CITY OF VANCOUVER

POLICY REPORT DEVELOPMENT AND BUILDING

SUBJECT: CD-1 Text Amendment -
Vancouver General Hospital (Nurses' Residence)
2851 Heather Street

DP103

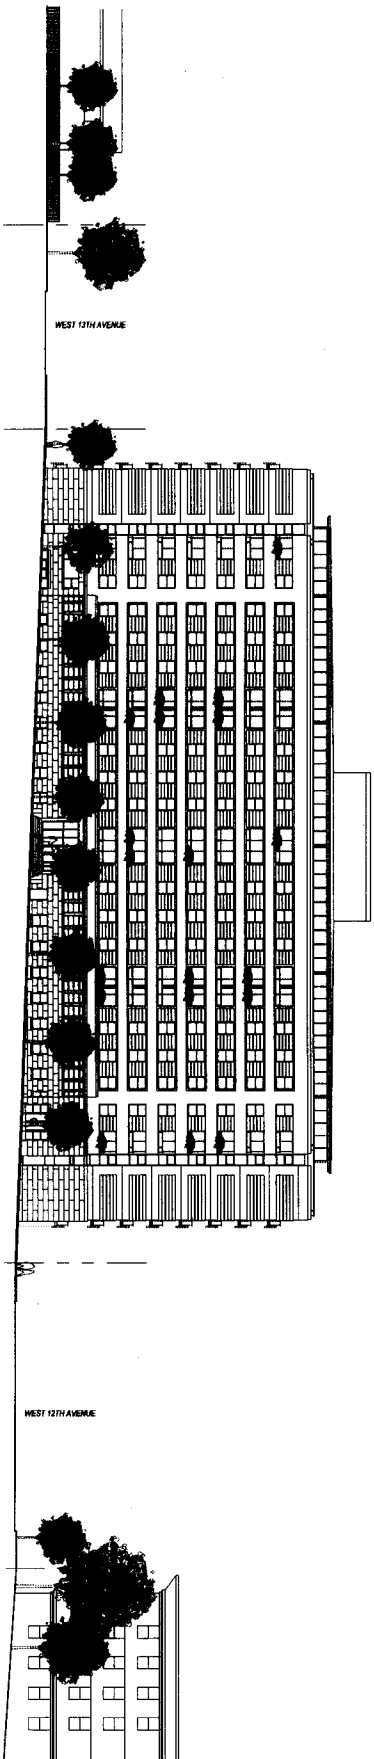
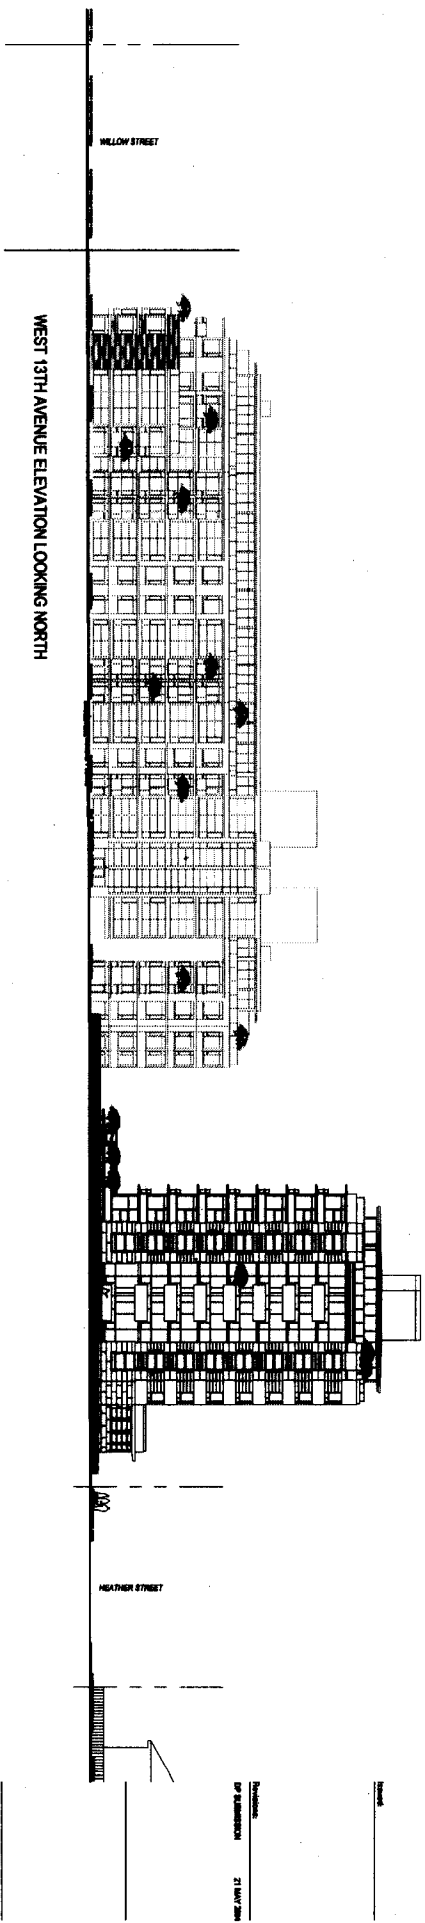
- i) Design development to the west elevation to reduce apparent project scale.

The Panel found the architectural language very appropriate and supportable: sufficiently different while complementing the existing building. Some Panel members questioned the stepping of the massing on the west side as being too small a gesture and unnecessary because it takes away somewhat from the regular shape of the two buildings. There was a recommendation for greater consideration of how the west façade comes to the ground to make it more pedestrian friendly.

- design development to simplify the west end of the 12th Avenue building and retain the autonomy of that building as a simple “bar” building;
- design development to enhance to the southeast corner of the daycare where the recess is rather severe.
- design development to enhance the formal logic of the green spaces, with particular emphasis on the auto court. This includes further clarification of the design and detailing strategy of the site with respect to the integration and contrast between both of the adjacent walkway and the power plant site; There was also a suggestion to consider relocating some of the trees that need to be removed.
- explore the possibility of a green roof.

The Applicant responded that they will look at the opportunity for a green roof and said they do intend to further develop the design of the auto court. Special attention will also be given to the base of the west elevation.”

Project: 21 MAY 2008
 DP 104

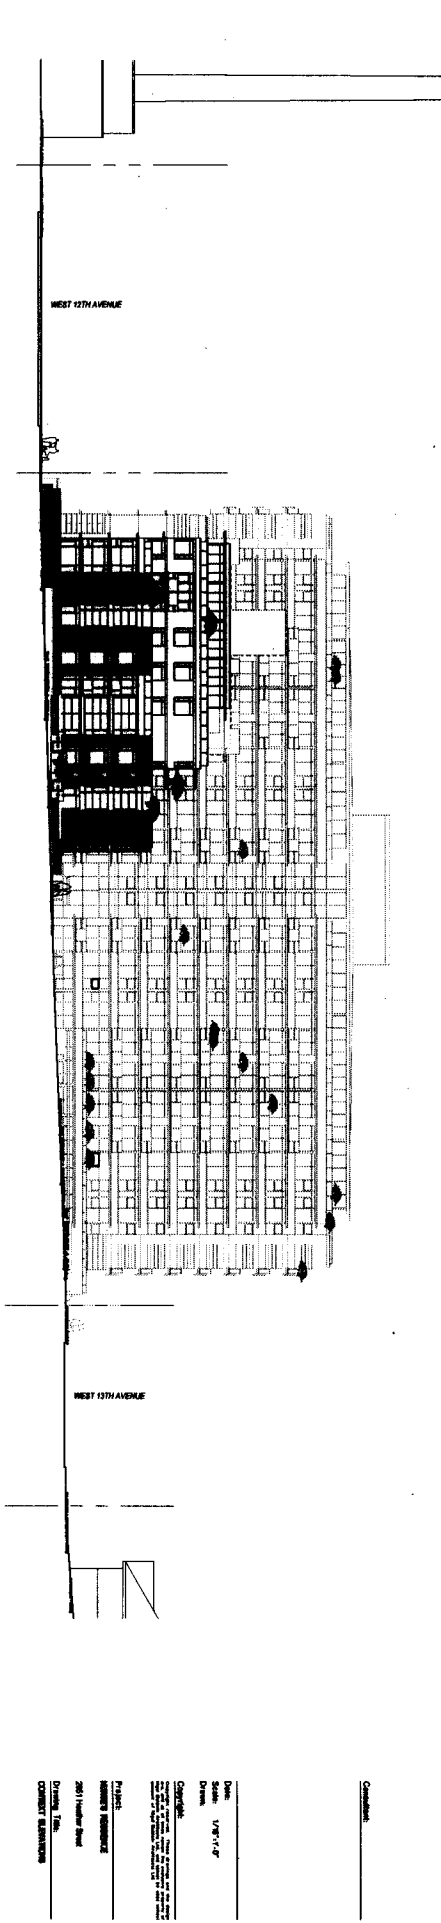
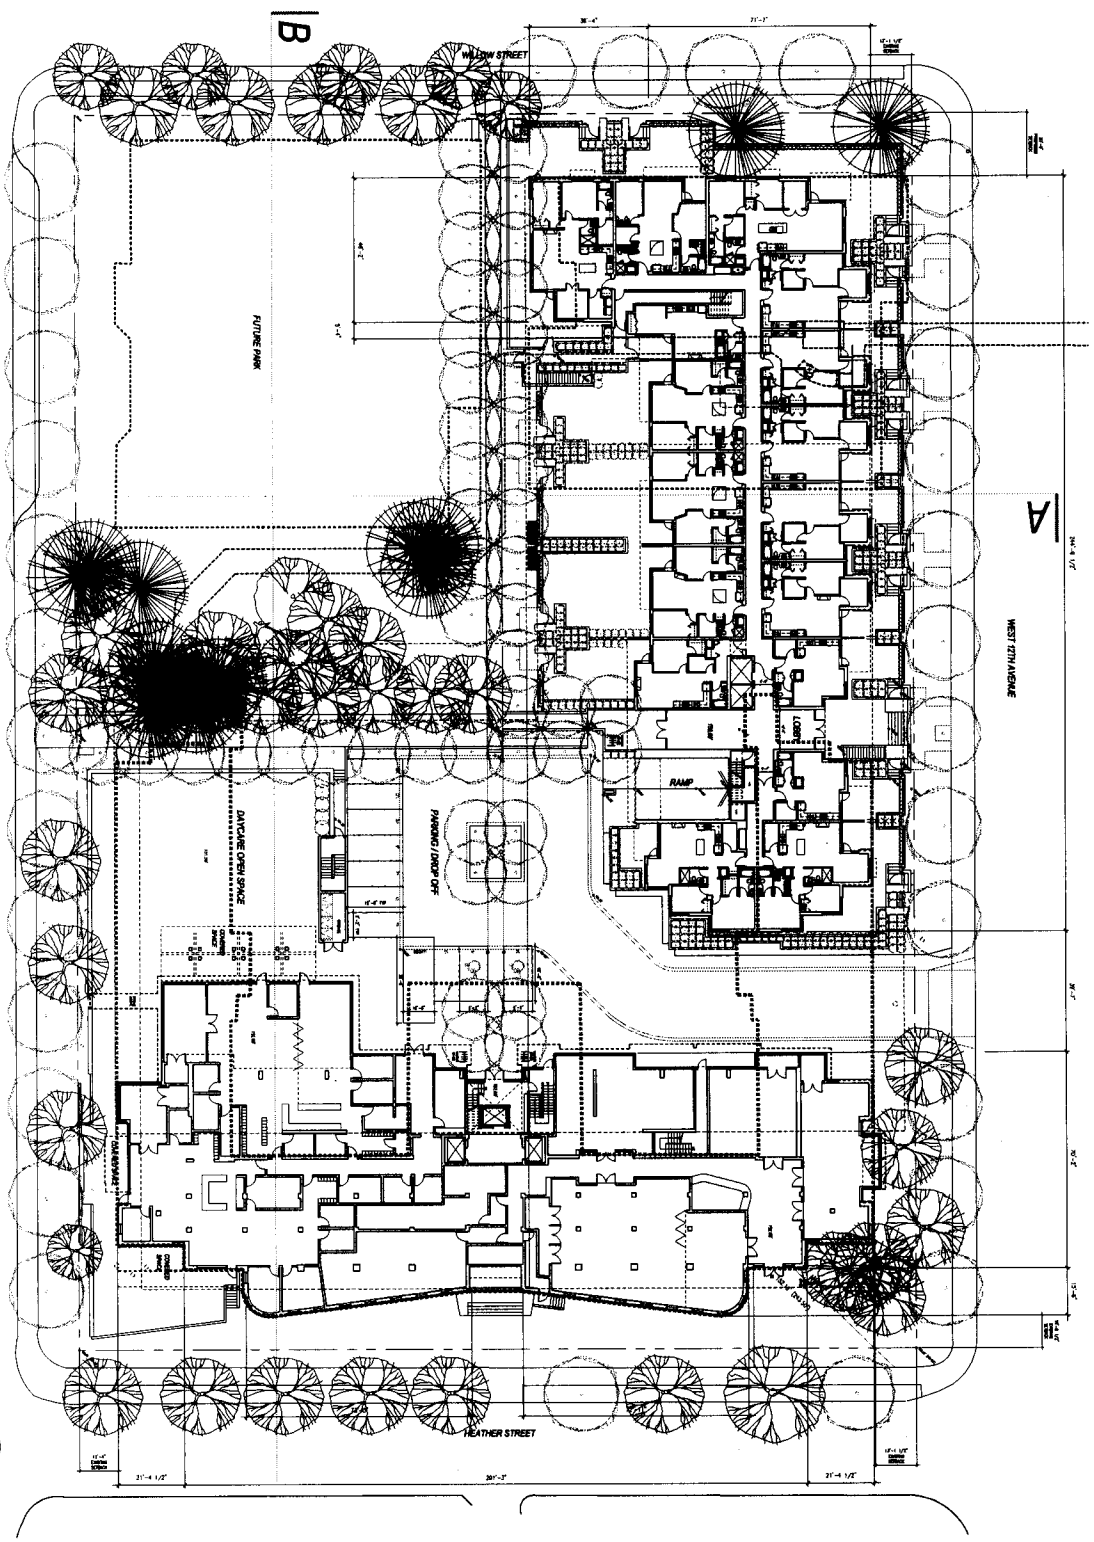
- ii) Design development to the westerly portion of the West 12th Avenue fronting building to improve the massing relationship to the Willow Street pedestrian corridor as well as the on-site and Energy Centre open space.
